RESIDENTIAL PLAN CORRECTION SHEET

ADDENDUM TO Permit No. 015-85
 Owner ABE TOSSINGER
 Contractor BECK'S CONSTRUCTION
 Location 120 VINCENTTES

subject 120 VINCEWODES RESIDENCE BUILT
BY DECK'S CONSTRUCTION

NOTE: THE TRUSSES WERE INSTALLED END FOR END AND MODIFIED AS NOTED ON THIS DRAWING IS THIS ACCEPTABLE TO BECK'S CONST. T-1B

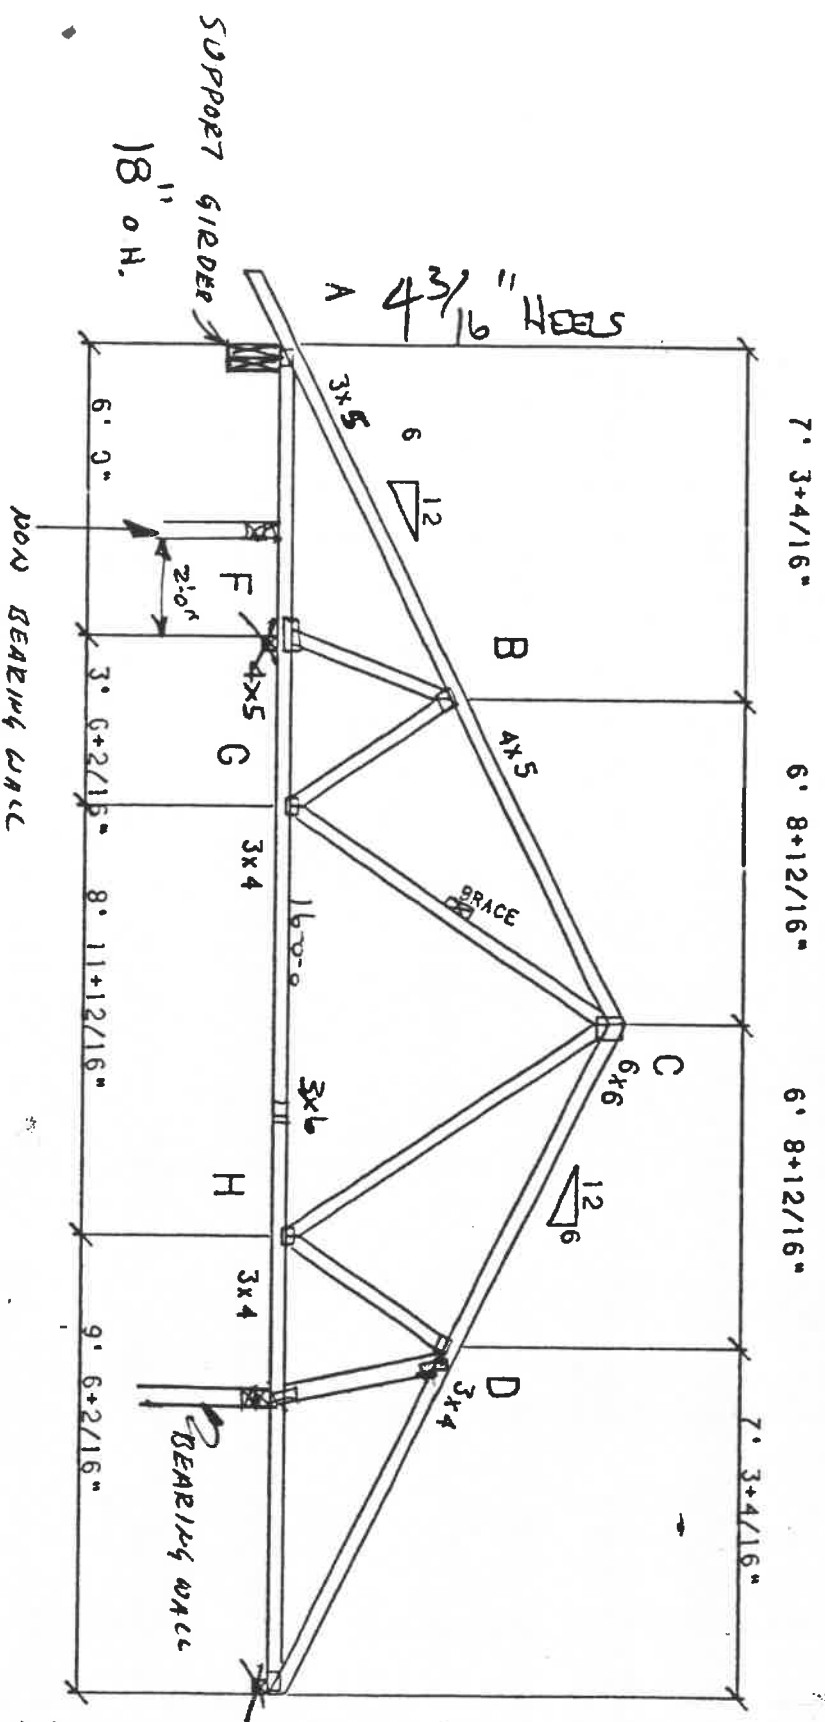
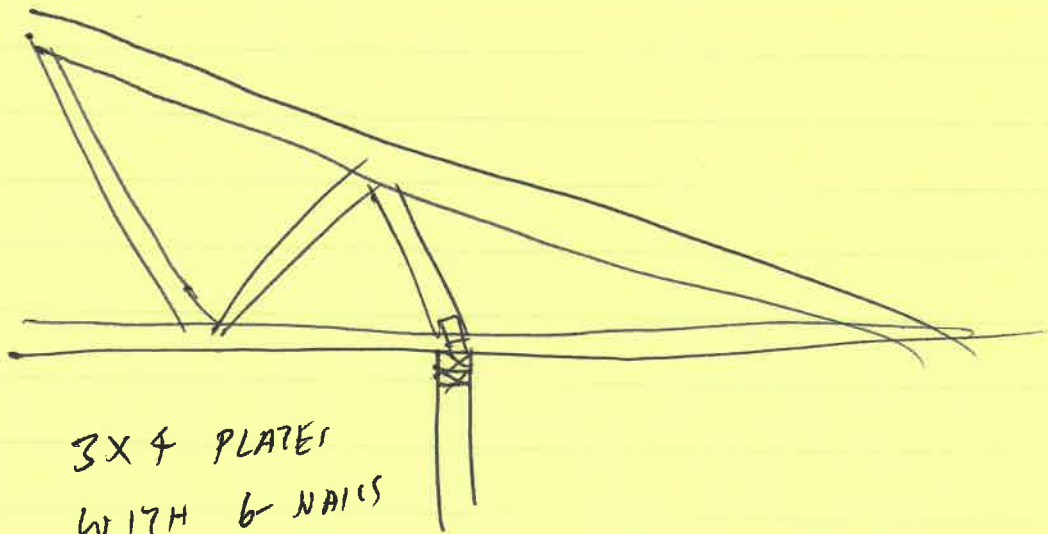
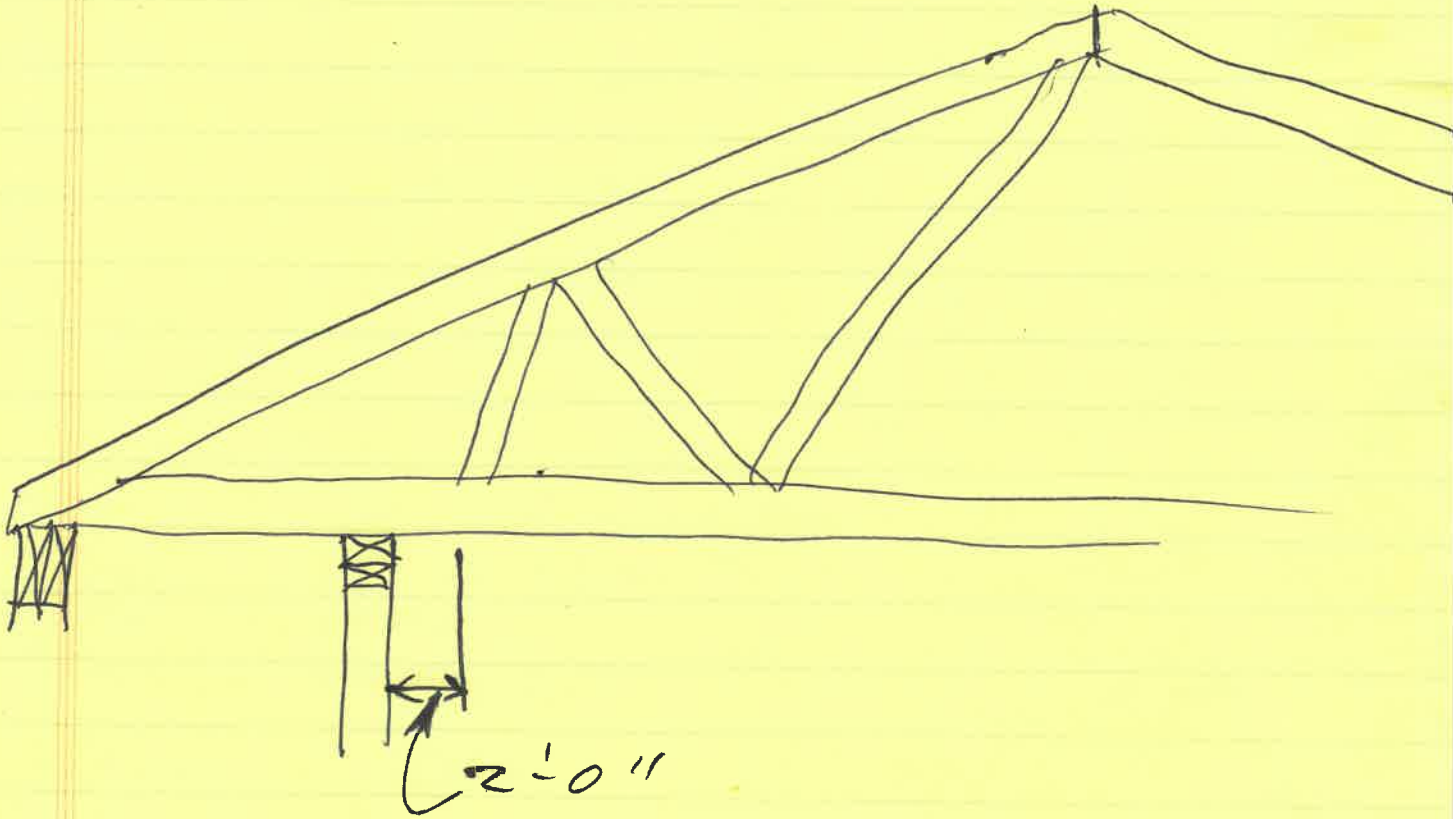
THE TRUSSES FOR THIS JOB WERE
INSTALLED END FOR END AND
MODIFIED AS PER THE ATTACHED
DRAWING, WILL YOU ANALYZE THIS
AND NOTIFY ME IN WRITING IF
YOU WILL APPROX. IT OR NOT.

BRACING FOR DINING ROOM HEADON

3X4 PLATES
WITH 6 NAILS

NOTE: REPLY TO TRUSS MODIFICATIONS MAJOR I/P FILED BY BECK'S CONSTRUCTION.
